Access Compliance Report

Public Rights-of-Way

Intersection ID: 28287	Main Street: BRANDON_BROOK_DR	Cross Street: OLD_ARDREY_KELL_RD	Location: NE
ADA ID: 741D40C6D358	Ramp Type: Perp	Initial Pass/Fail: Fail	Overall Compliance: No
		Severity Score: 25

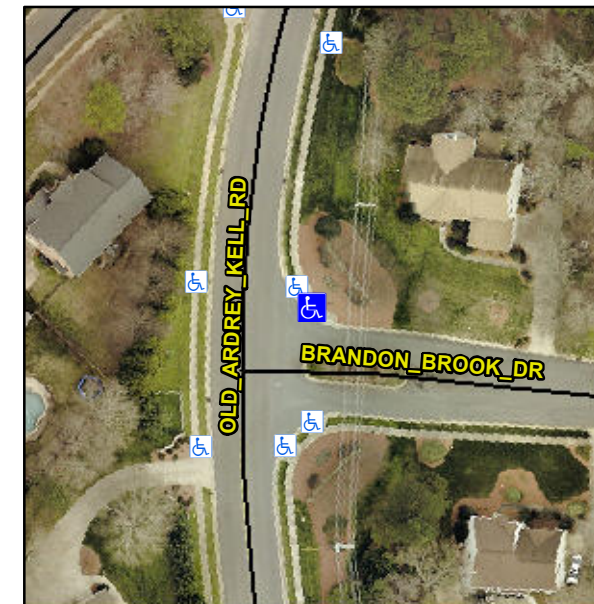
Not Found, R304.5.3

Compliance	Description	Data	Compliance	Description	Data
N/A	Ramp Length (in)	47.0	Yes	Ramp Slope (%)	7.7
Yes	Ramp Width (in)	52.0	No	Ramp XSlope (%)	7.3
N/A	Flare Type LT	N/A	N/A	Flare Type RT	N/A
N/A	Flare Slope LT (%)	N/A	N/A	Flare Slope RT (%)	N/A
N/A	Flare Traversable LT?	N/A	N/A	Flare Traversable RT?	N/A
N/A	Landing Length (in)	N/A	N/A	DWS Provided?	N/A
N/A	Landing Width (in)	N/A	N/A	DWS Contrast?	N/A
N/A	Landing Slope (%)	N/A	N/A	DWS Length (in)	N/A
N/A	Landing X Slope (%)	N/A	N/A	DWS Full Width?	N/A
N/A	Landing Curb? (Y/N)	N/A	N/A	DWS Offset (in)	N/A
N/A	Shared Landing?	N/A			
N/A	Gutter Ponding?	N/A	N/A	Gutter Slope (%)	N/A
N/A	Gutter Lip Ht (in)	N/A	N/A	Gutter X Slope (%)	N/A
N/A	Painted X Walk1?	No	N/A	Painted X Walk2?	N/A
	X Walk 1 Direction	To SW		X Walk 2 Direction	N/A
N/A	X Walk 1 Width (in)	N/A	N/A	X Walk 2 Width (in)	N/A
	X Walk 1 Slope (%)	5.4		X Walk 2 Slope (%)	N/A
	X Walk 1 X Slope (%)	6.2		X Walk 2 X Slope (%)	N/A

Remove & Replace Entire Ramp.
